Planning and Zoning Commission- Regular Meeting AGENDA

Monday, June 08, 2020 at 5:30 PM
Ketchum City Hall
480 East Avenue North, Ketchum, ID 83340

- 8. ACTION - 4th & Main St Mixed-Use Building Pre-Application Design Review:** Main Street between 4th and 5th Streets (Ketchum Townsite: Block 5: Lots 1, 2, 3, and 4.) The Commission will consider and give direction on a Pre-Application Design Review submitted by Chris Ensign of Solstice Homes Development for a new four-story, 47.5 foot tall, 59,130-square-foot mixed-use building located on four lots on Main Street between 4th and 5th Streets within the Retail core of the Community Core (CC-1). *Continued from March 9, 2020.*

EAST FIFTH STREET

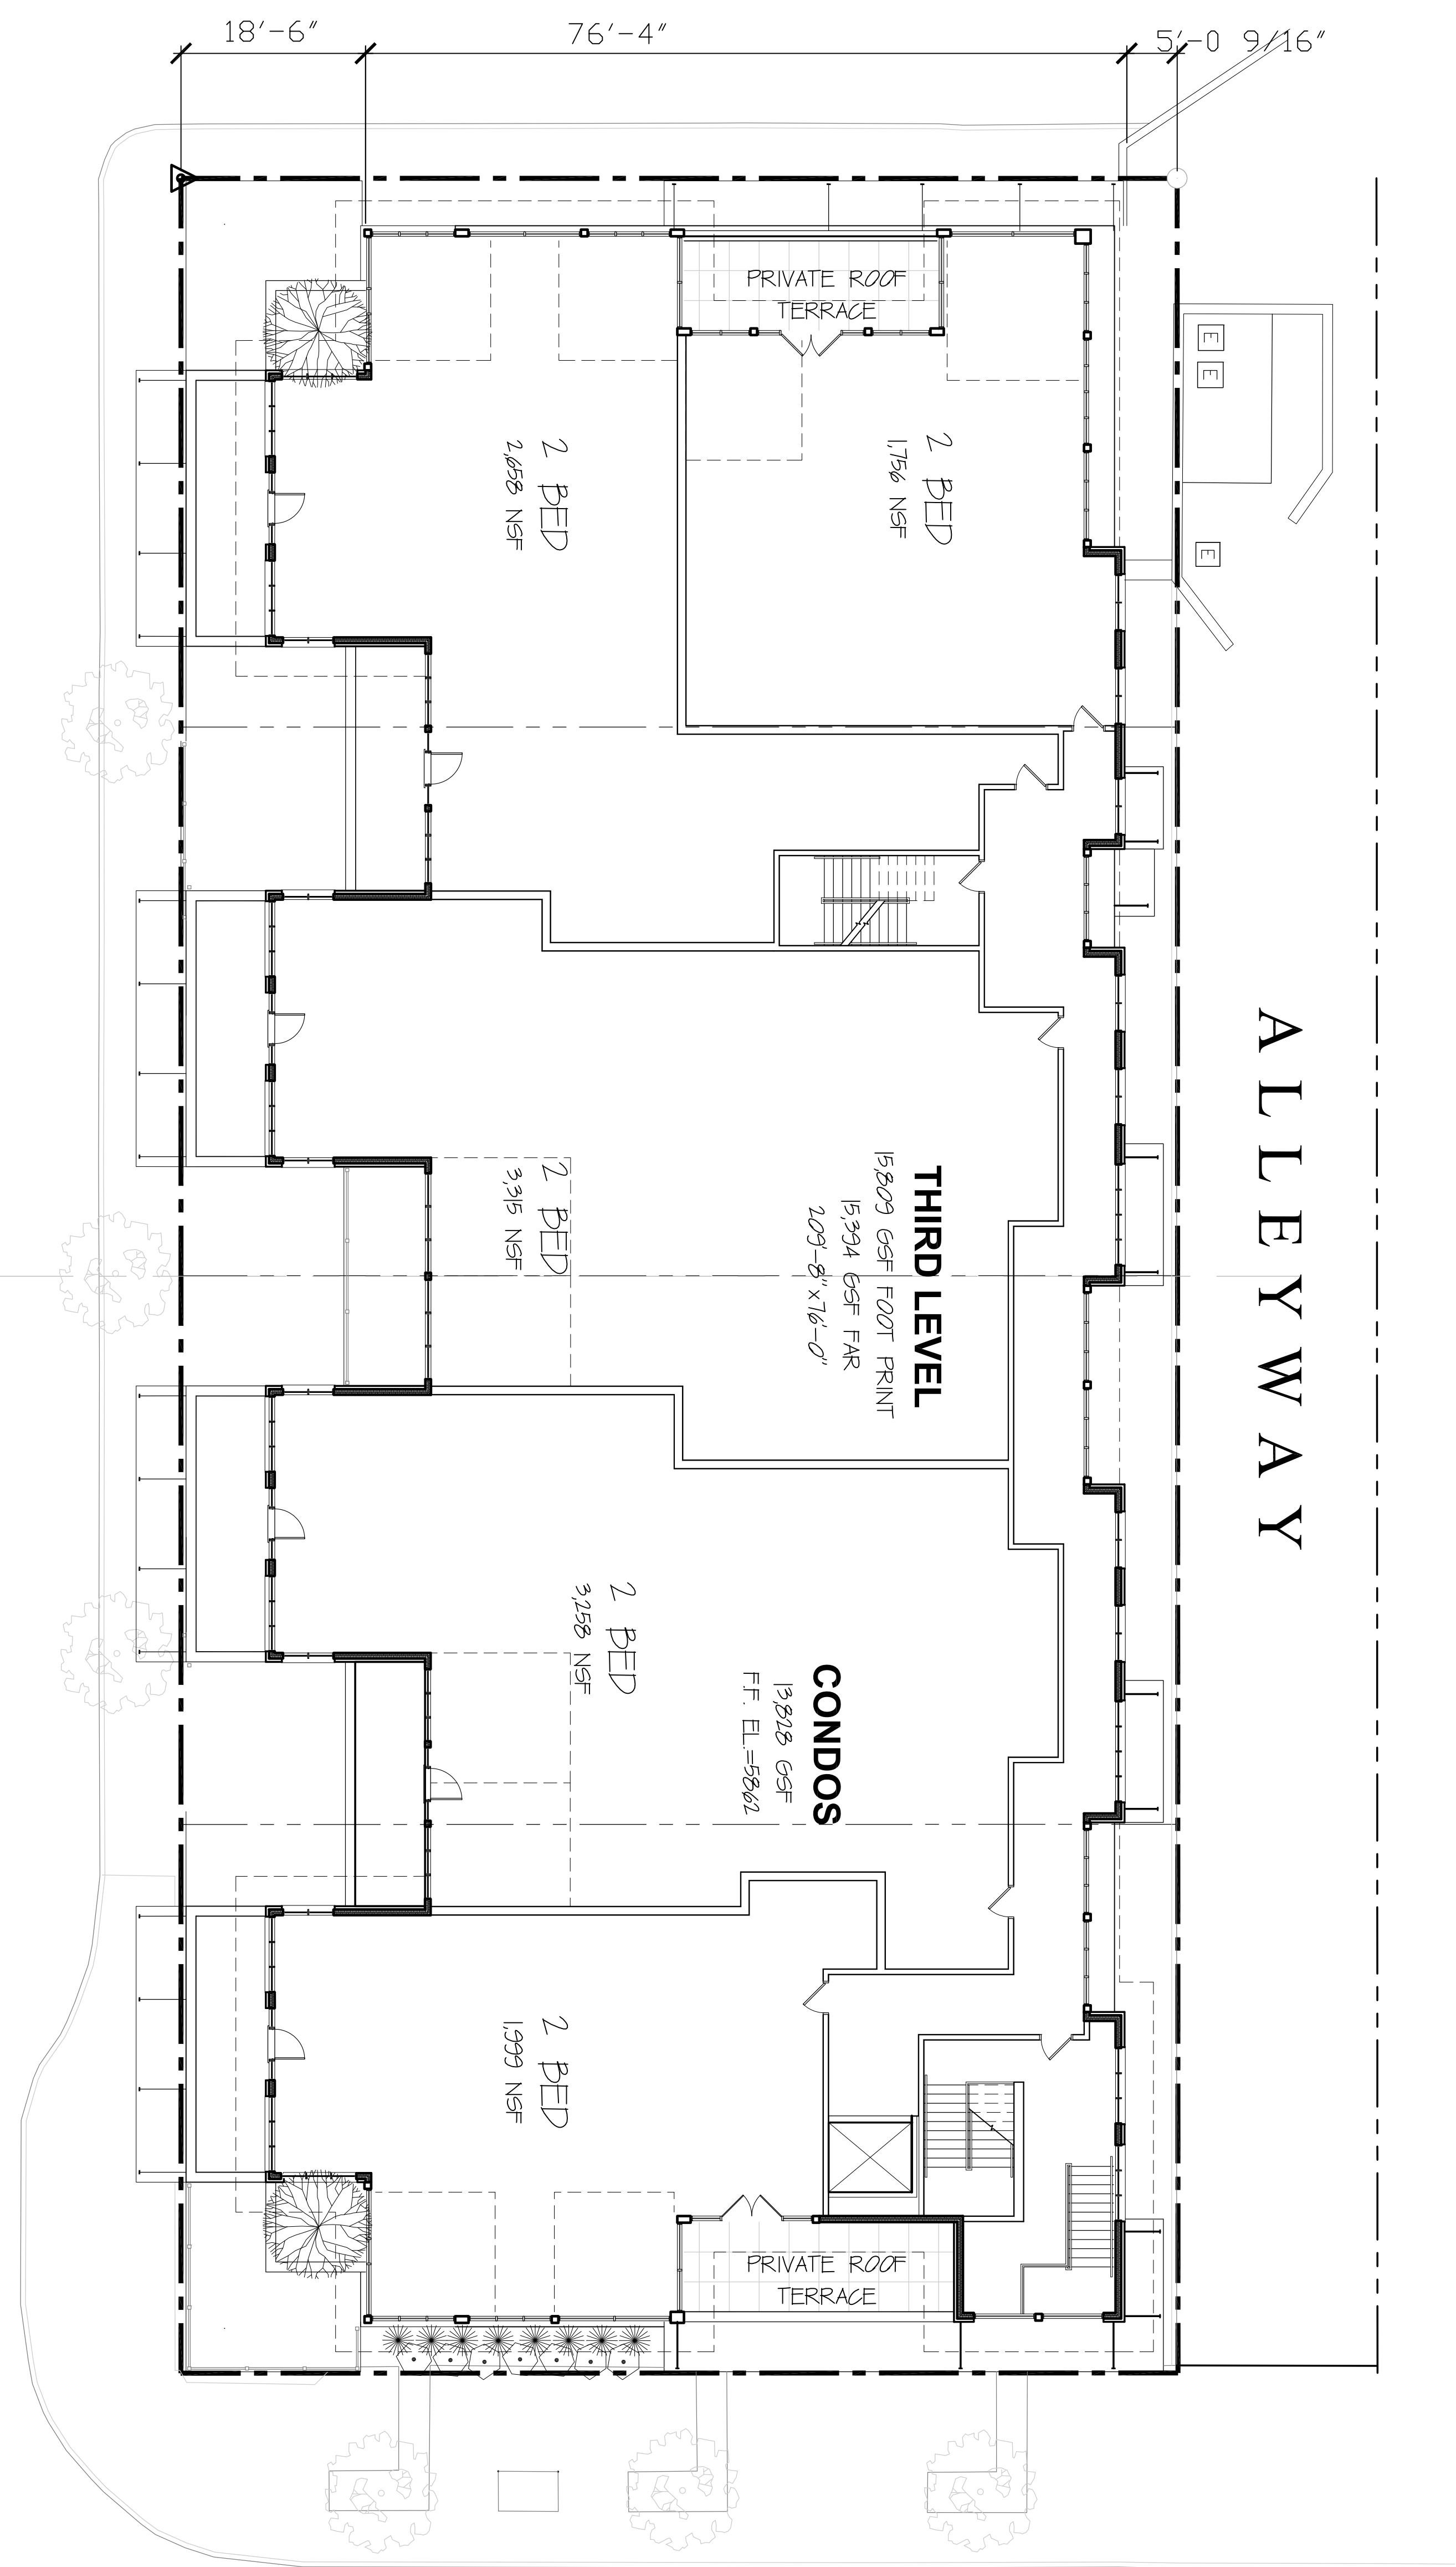
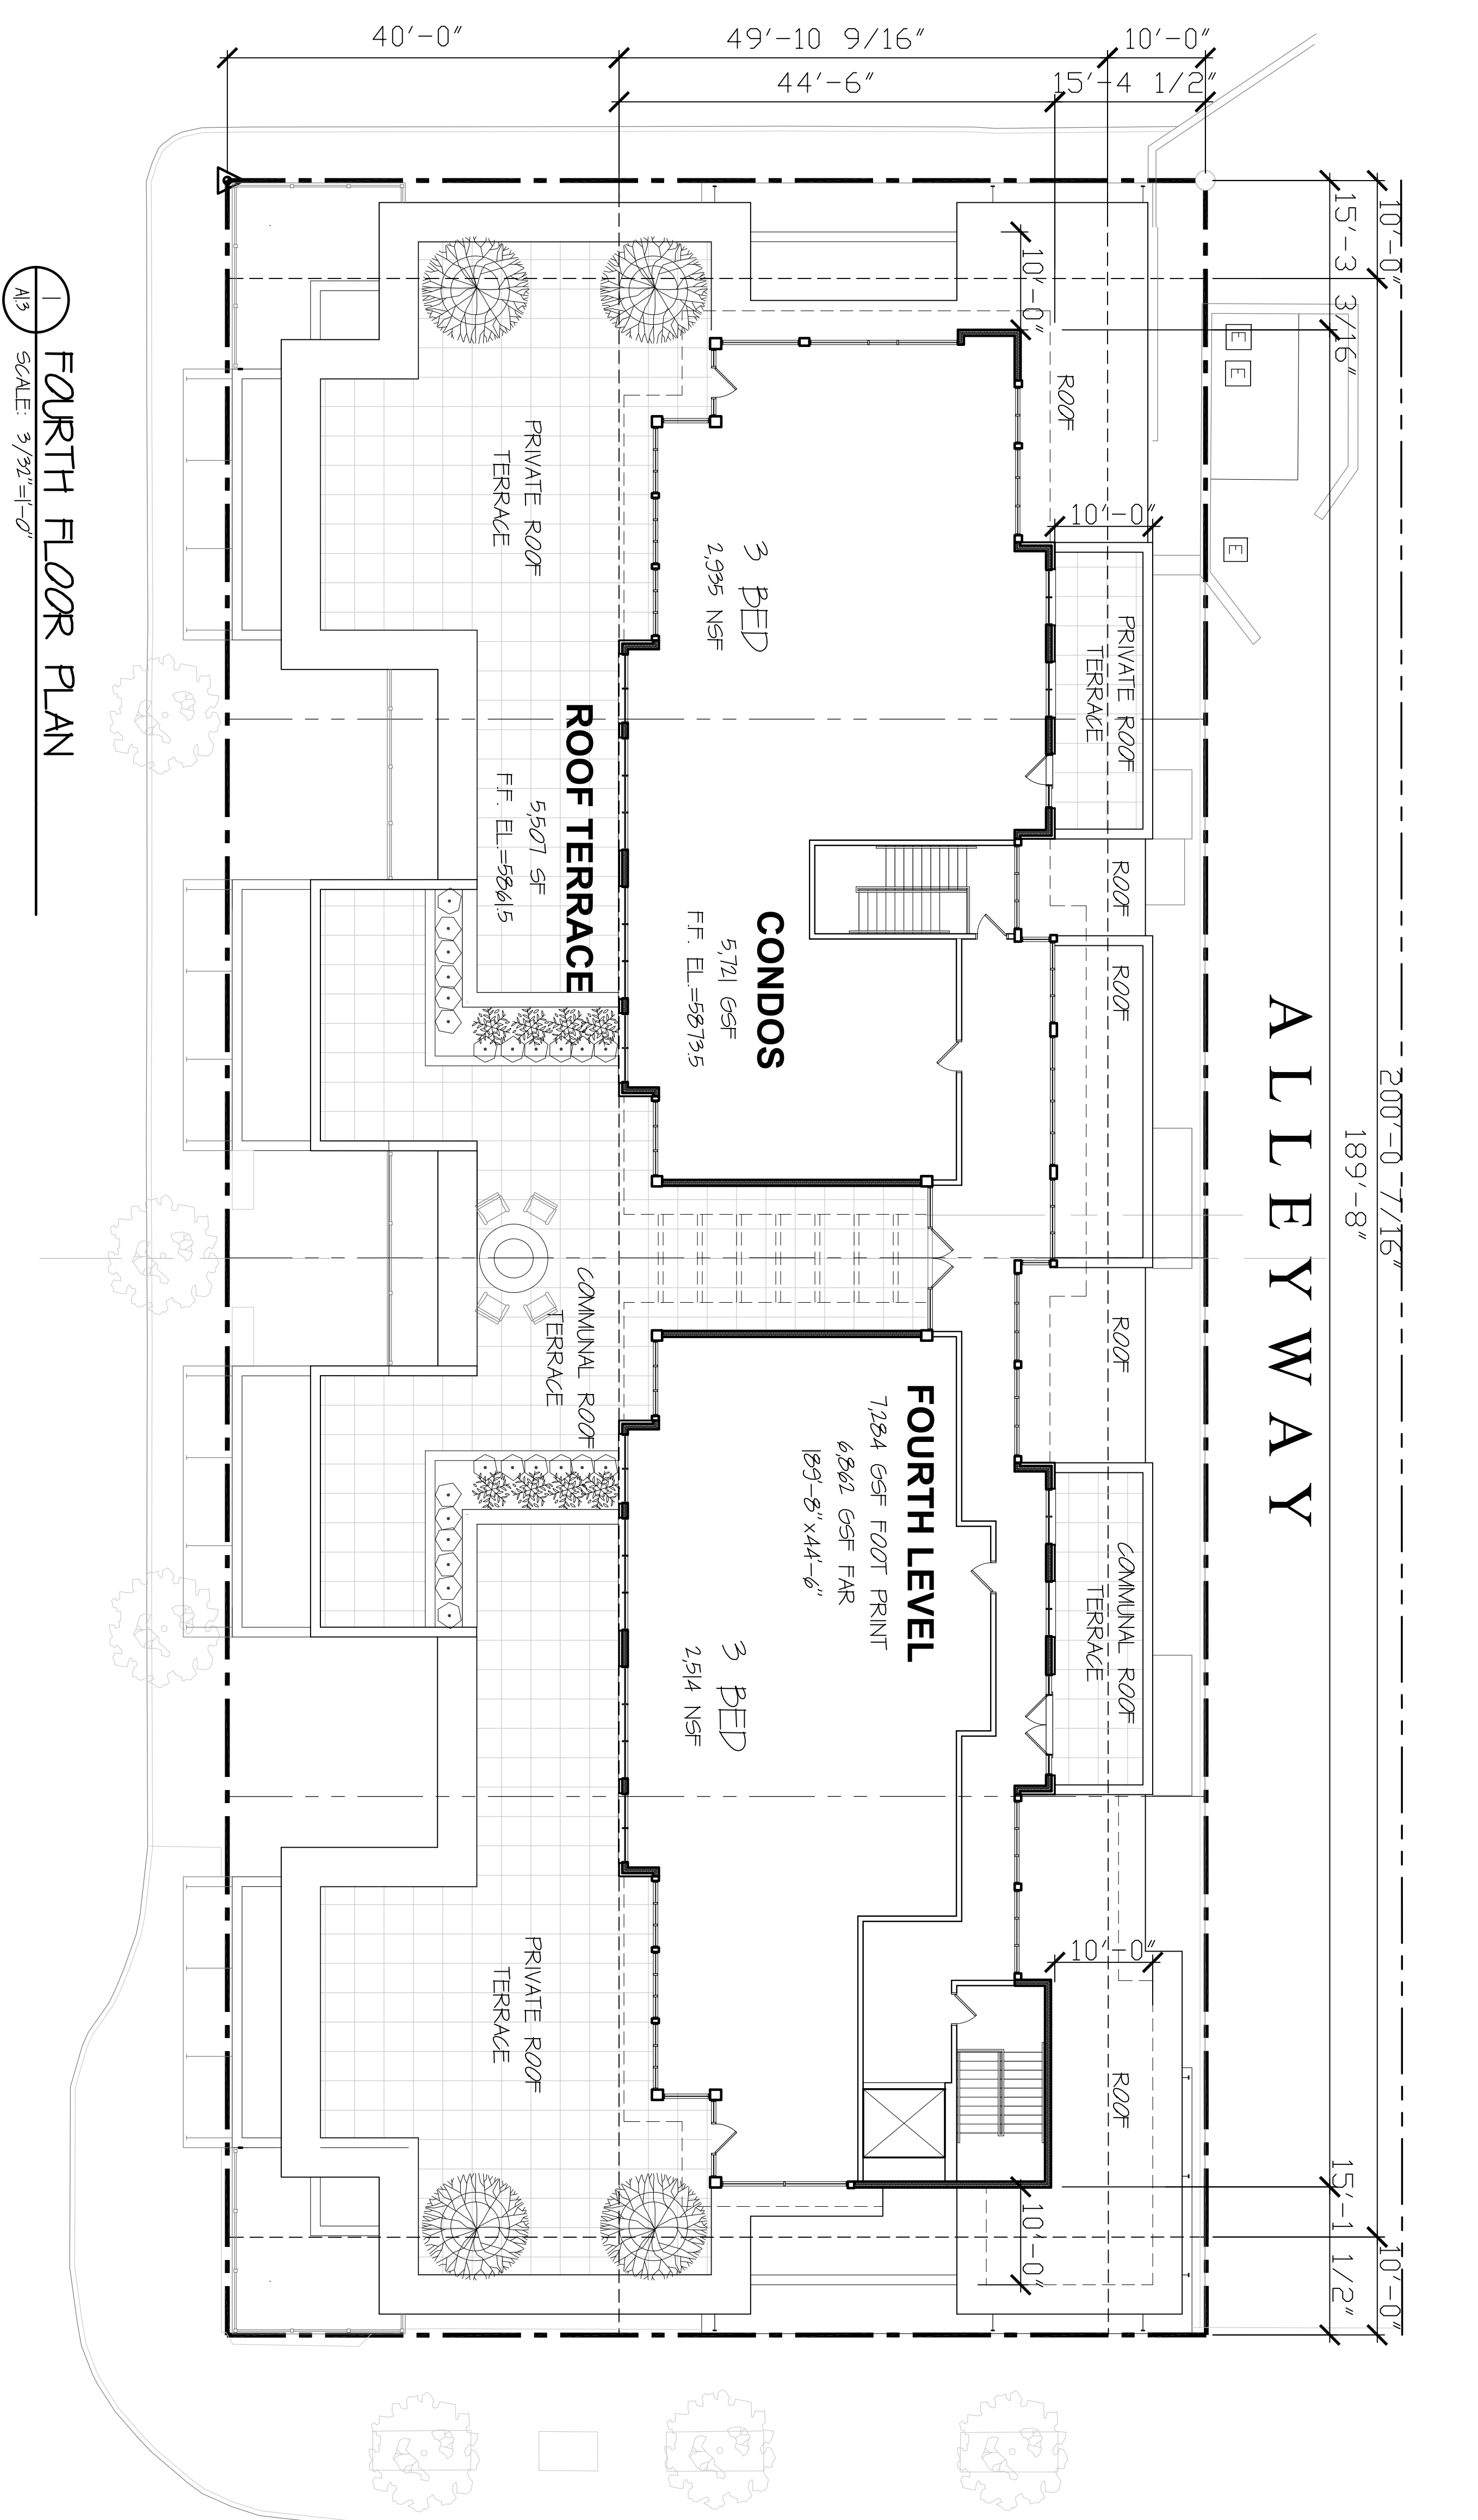
The floor plans on Sheets A1.0, A1.1, A1.2, and A1.3 don’t show the location of window or door openings. The elevations indicate residential units with walls comprised entirely of windows. The building’s outsides don’t match its insides—the exterior of the building doesn’t match the residential use proposed within the building. This discrepancy raises a concern that of the preliminary design drawings unrealistically depict the building’s appearance.

1 RENDERED ELEVATION
SCALE: 1/8"=1'-0"

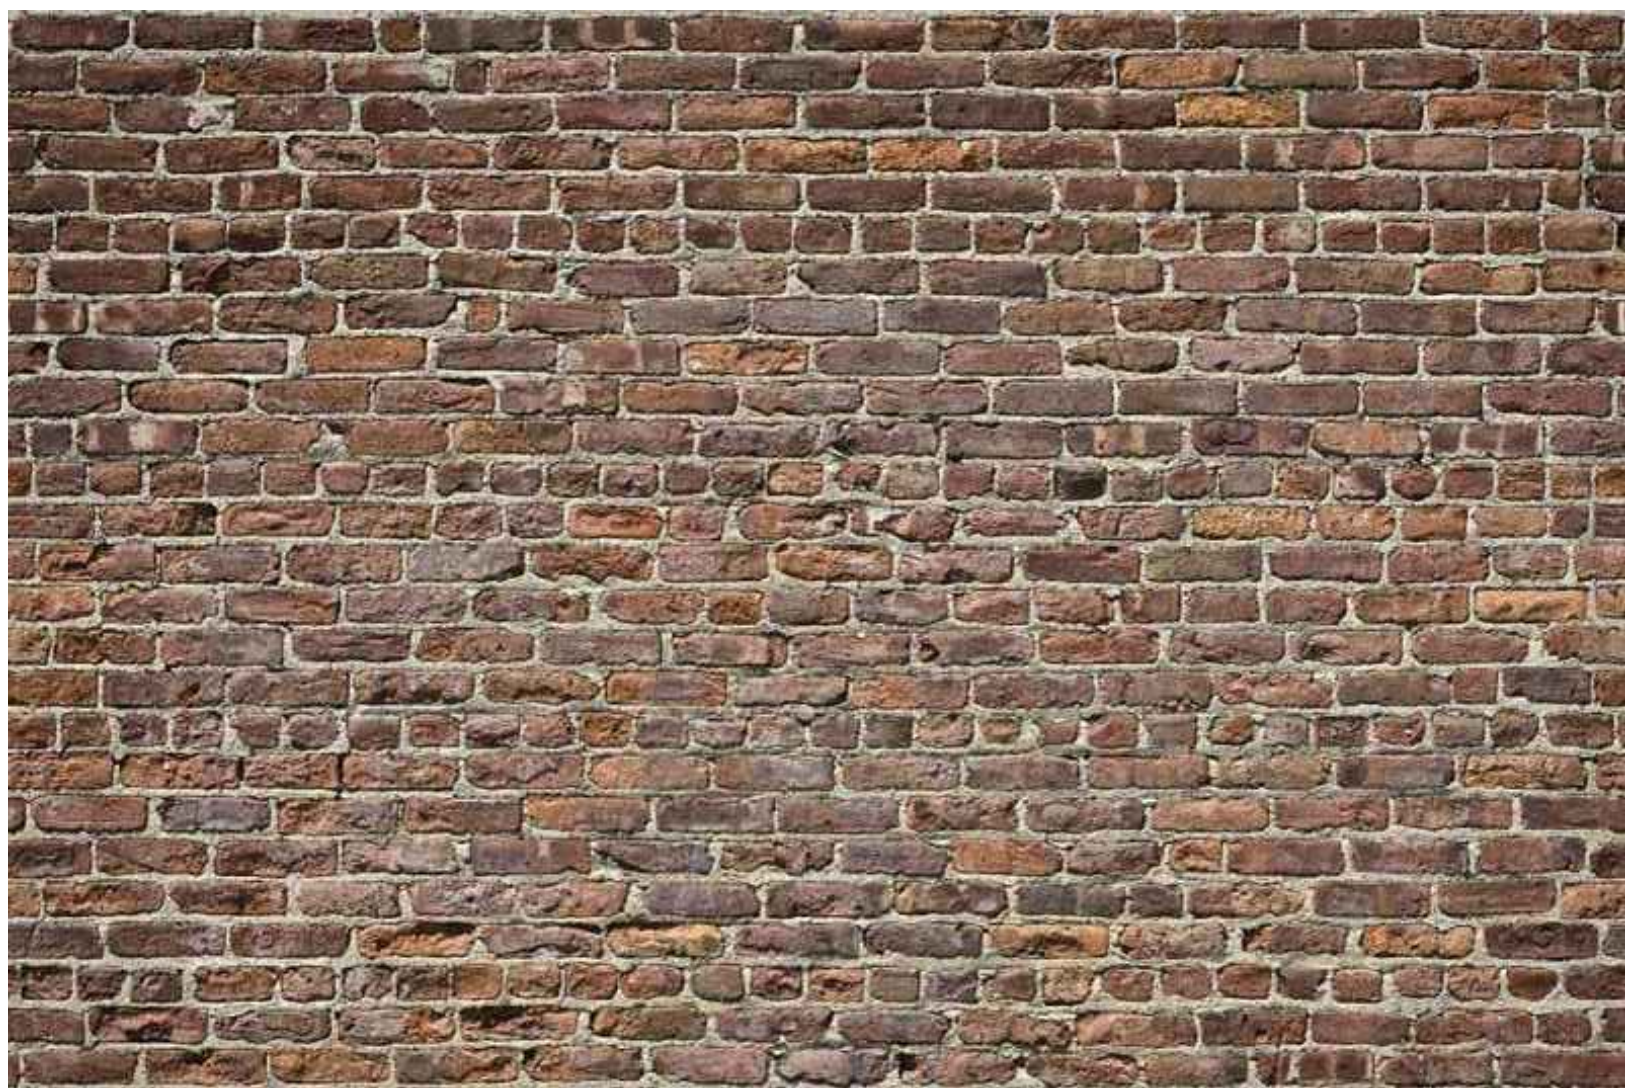
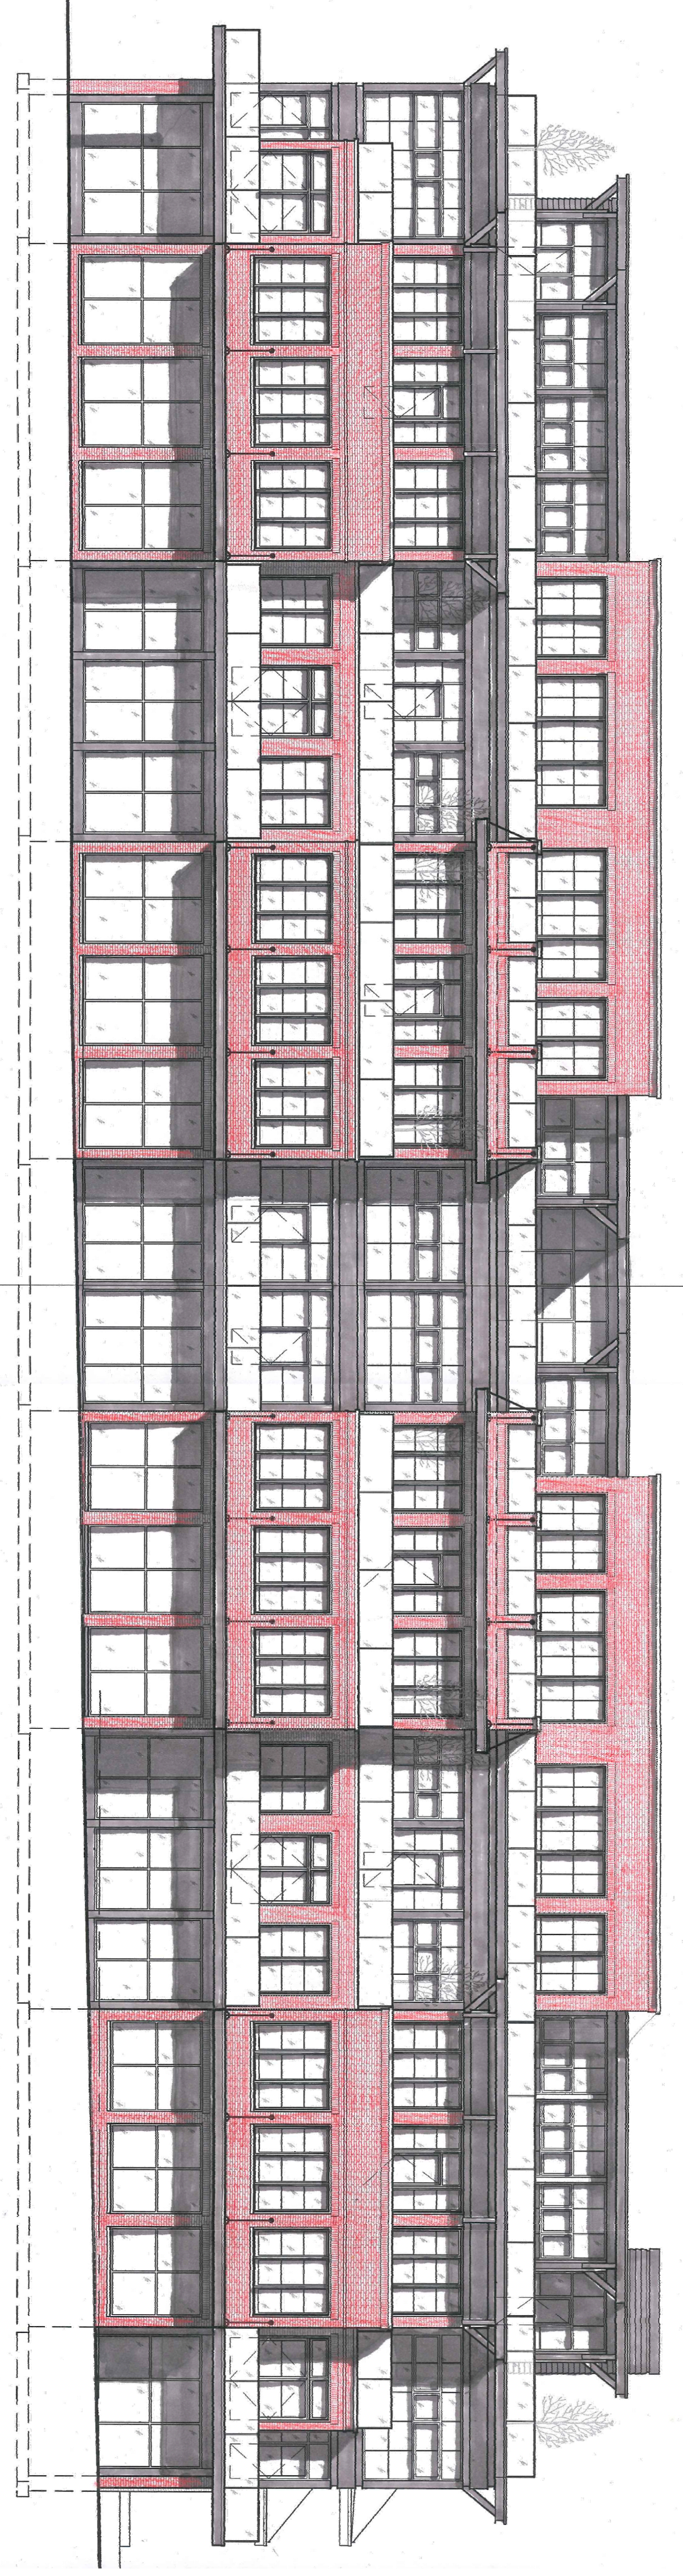
Figure 1: Rendered Elevation, Project Plans: Sheet A5.1
